Permit Type	Permit Number	Opened Date
Building/Residential/Alteration/SFD	B26000033	01/05/2026
Description of Work		
SFD/ Construct one new non-load-bearing interior partition wall in existing basement to create a craft room**NOT APPROVED AS A SLEEPING ROOM OR ACCESSORY APT, SUBJECT TO FIELD INSPECTION**

**ON-SITE SEWAGE DISPOSAL SYSTEM
HOWARD COUNTY HEALTH DEPARTMENT
BUREAU OF ENVIRONMENTAL HEALTH**

From: Eshenbaugh, Melanie
Sent: Thursday, January 29, 2026 4:48 PM
To: 'SMB Home Improvements LLC'
Subject: RE: B26000033

Existing basement floor plan – no proposed work shown

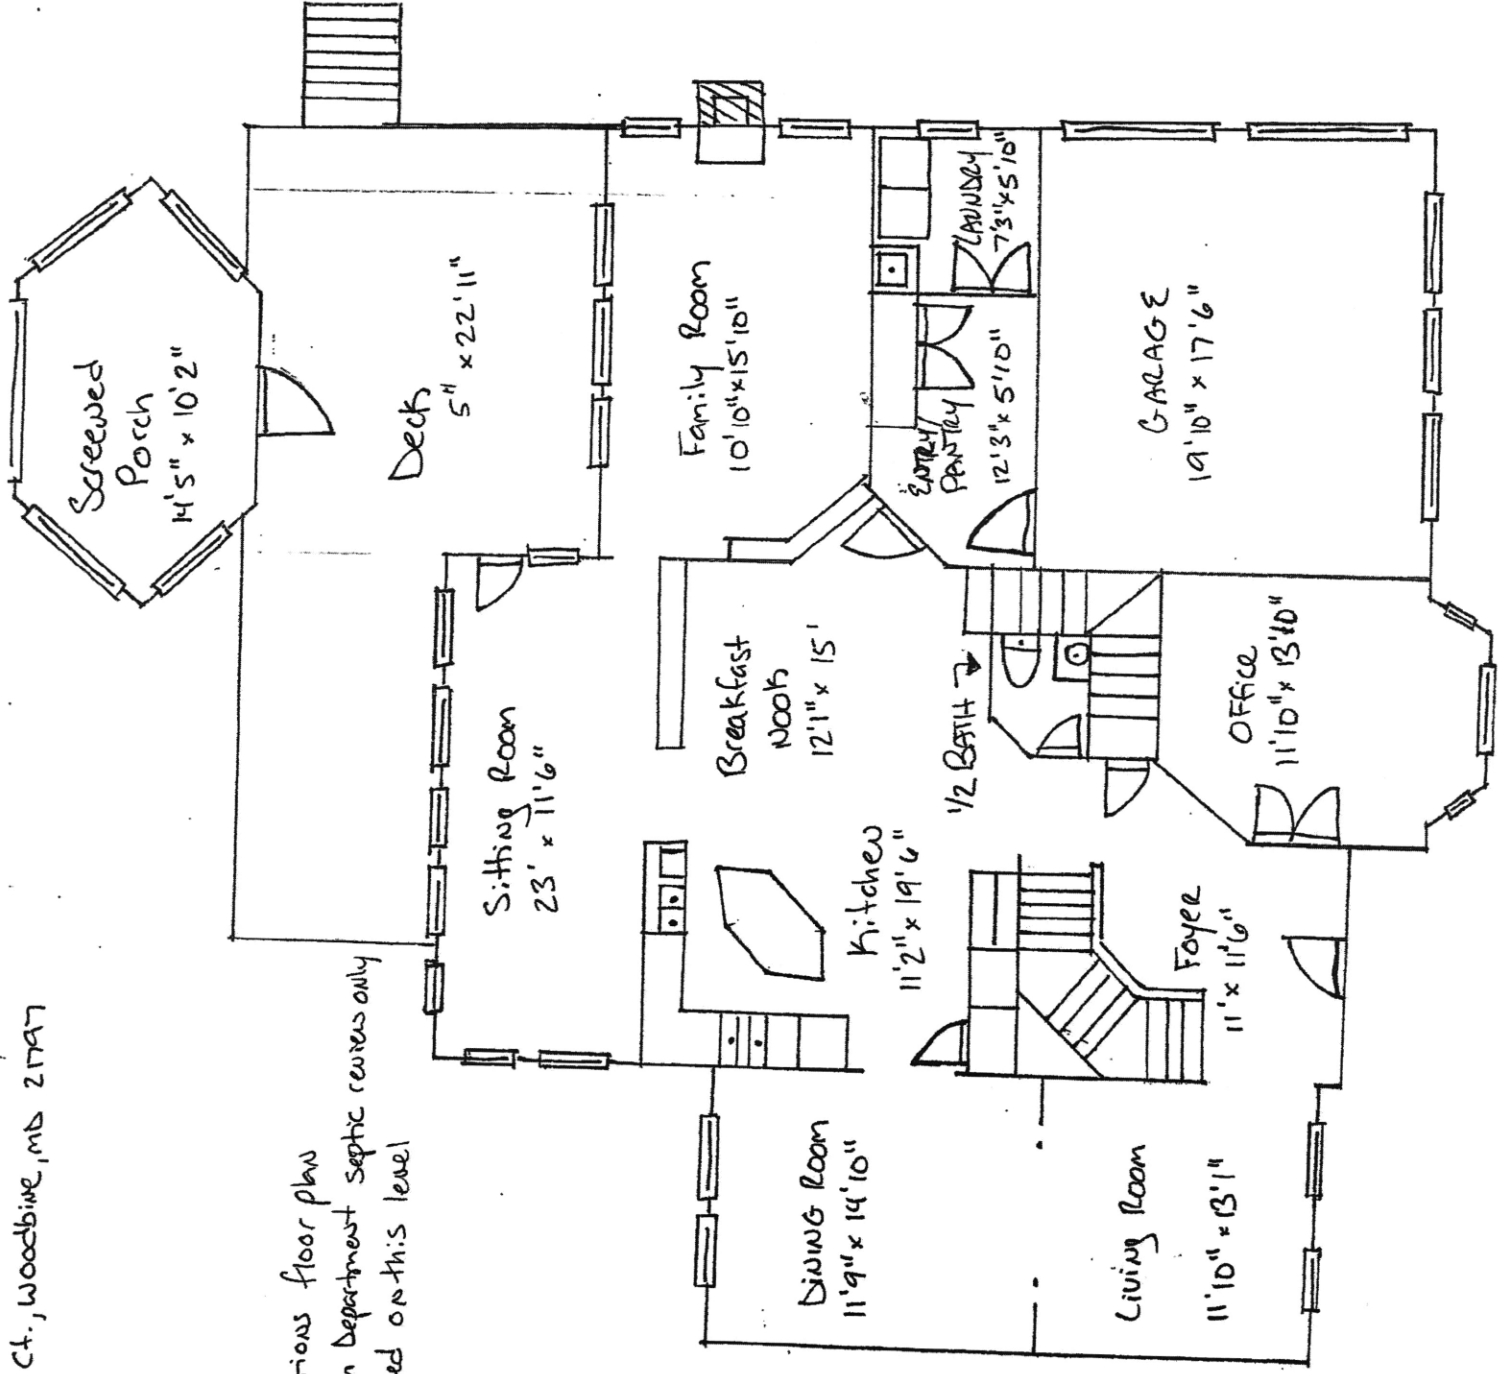
After review of the submitted plans for the building permit (B26000033) proposal of a craft/pet room, we kindly request that you submit simplified floor plans for the 1st & 2nd levels of the residence in order to determine whether the septic system is adequate for both the existing and proposed living space improvement. Currently, the HD septic permit is approved for a 4-bedroom home and the room proposed meets the bedroom definition in Howard County code (see attached). The Howard County Health Department in its review of Building Permit applications, must accurately determine the number of bedrooms in a proposed dwelling or existing dwelling with a proposed addition in order to ensure adequate onsite sewage disposal on properties not served by public sewer. As the definition of a bedroom in Howard County Code Title 3, Subtitle 8, Onsite Sewage Disposal Systems, differs from the definition in the Building Code, the Health Department must review floor plans as part of the building permit review process. Since the proposed additions/renovations to the existing dwelling includes finishing a room in the basement, we must review simplified floor plans of all levels to move forward with the building permit approval process. The floor plans must contain a diagram of each room with dimensions, labeled with intended use and level of the dwelling including windows, doors, plumbing fixtures, and/or labeling of half/full bathrooms. Please let me know if you have any questions and thank you kindly.

After review of the existing floor plans, it has been determined that the septic system is undersized based on the number of rooms in the home that meet our bedroom definition (septic system adequate for 4 bedrooms). The property owner would be able to either modify the existing rooms to keep the same number of bedrooms approved on the septic permit (see attached record) or upgrade the septic system to be sized appropriately based on the total number of bedrooms reflected on the floor plans (currently 6 rooms meet our bedroom definition). As specified in the bedroom definition that was previously provided, a bedroom is 90 sq. ft. or greater in size, with 1 window and 1 interior door. For a room to not meet our HCHD bedroom definition (HC Section 3.801), it must not have a closet AND can meet any of 1 of these 3 criteria: built-in bookcases that are around the perimeter of room; a minimum of a 4' wide opening, without doors into another room; or a half wall (4' max. height) between the room (any room not intended as a bedroom e.g. office, storage, etc.) and another room. If the property owner would like to upgrade the septic system, then a certified (MDE) engineered onsite sewage disposal system (OSDS) plan would need to be submitted to the HD office for review. After approval of the OSDS plan, then a licensed septic contractor would need to pull a septic permit in our office to upgrade the septic tank and trenching to be adequate for the property. Please let me know if you need any further clarification and thank you kindly.

- Plan is representative and not to scale.
- Existing conditions floor plan (Basement).
- Room labels indicate intended use only for Health Department review.
- No sleeping rooms proposed in basement.
- Proposed construction shown on separate Building Permit plans.
- Basement improvements do not increase the approved septic bedroom count.

The basement plan has also been updated to clearly identify the proposed office as a non-sleeping space. The room does not include a closet, plumbing, or an egress window, and the basement improvements do not increase the approved septic bedroom count.

Partial Basement layout - Area of work only (Not to Scale)

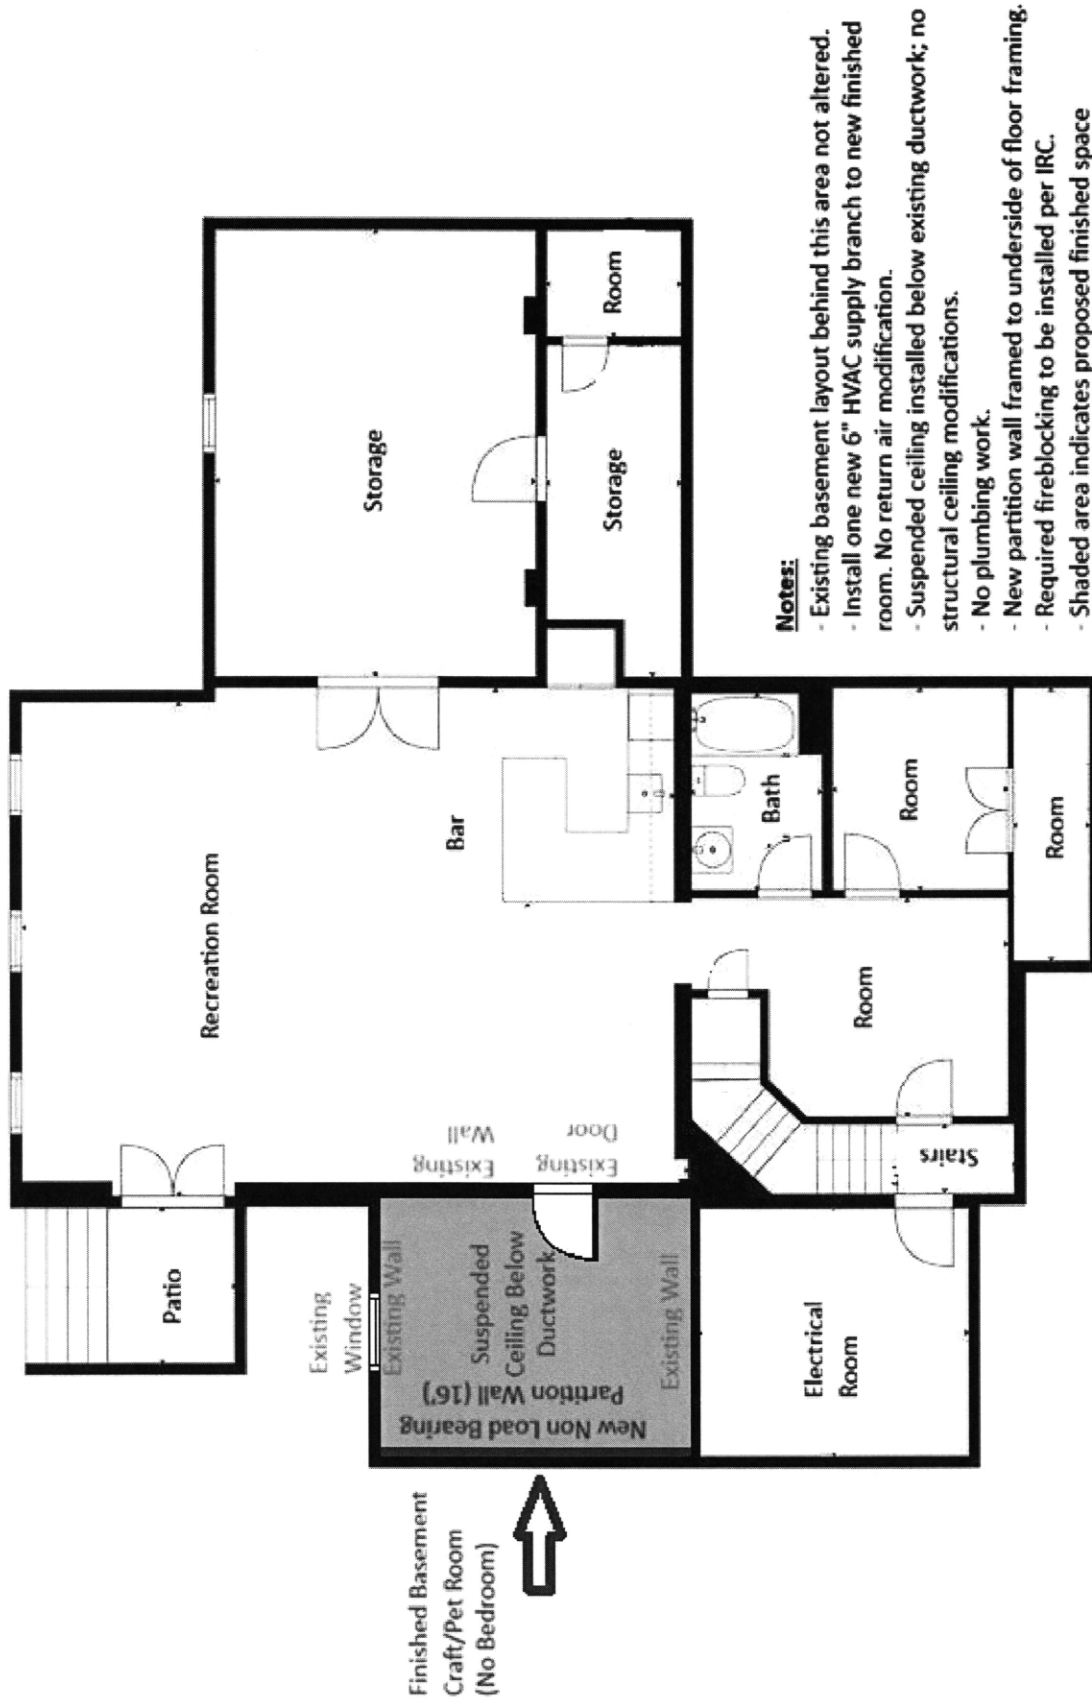
For the basement office, I wanted to confirm whether permanent built-in bookcase shelving, constructed as individual fixed shelves mounted on steel L-brackets fastened directly into wall studs, would satisfy the exception criteria you referenced. As a general example, the shelving would be approximately 10–12 inches deep, extend 6–8 feet along one wall, and include multiple fixed rows so the room cannot function as a sleeping space.

- Existing basement layout beyond this area not altered.
- Install one new 6" HVAC supply branch to finished room.
- No return air modifications.
- Suspended ceiling below ductwork.
- No plumbing work.
- Required fireblocking to be installed per IBC.
